APPENDIX I.1

Comments on the Draft EIS and Responses

Southgate Project

**Appendix I.1
Index of Commenters on the Southgate Draft EIS**

TA-2a

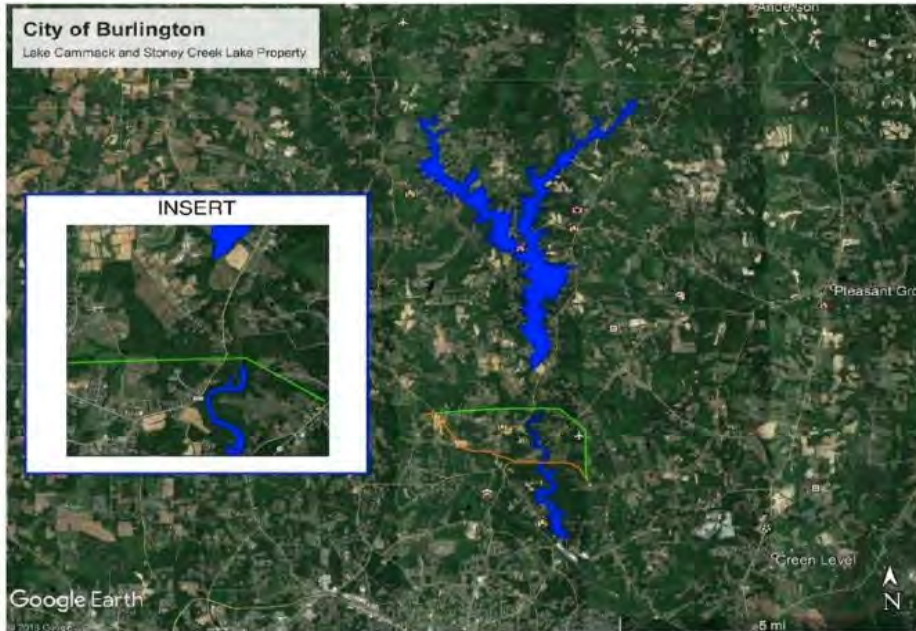
creek rather than the lake. The City of Burlington does not own the land along Stoney Creek running between Lake Cammack and Stoney Creek Reservoir. Unfortunately, MVP has not responded to this request leaving the City with concerns regarding potential impact to the water supply. Without sufficient detail to review the potential physical and environmental impacts effects upon the City of Burlington's drinking water reservoir, we are concerned that this crossing could adversely impact the integrity of the reservoir, water quality, and recreational activities.

The City of Burlington hereby requests and strongly encourages MVP and FERC to realign the pipeline so that it does not cross a City-owned water supply reservoir, including the above suggested routing or reconsideration of alternative routes presented in Section 3.4 the DEIS (pages 3-6 to 3-11), the Lake Cammack East and North-South Alternatives. Each of these routes would minimize risk to drinking water supplies.

The Stony Creek Reservoir intake is located approximately 1.8 river miles downstream of the Project's proposed HDD crossing. Mountain Valley representatives met with the City of Burlington officials on November 23, 2019 to discuss the crossing and will continue to coordinate during construction.

Figure 2. Ecological Cores and Habitat Fragments from the VaNLA 2017 with the proposed MVP Southgate project route.

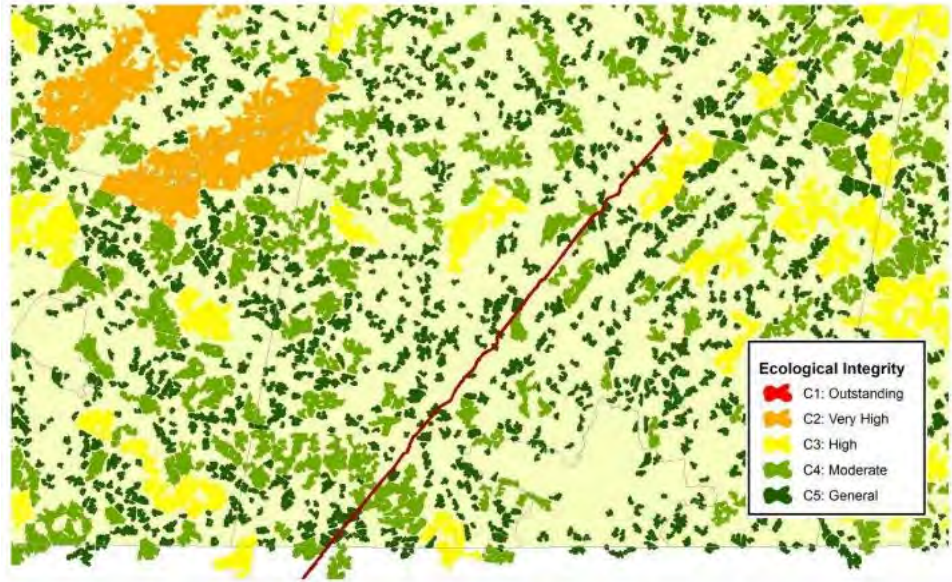
CO-30a
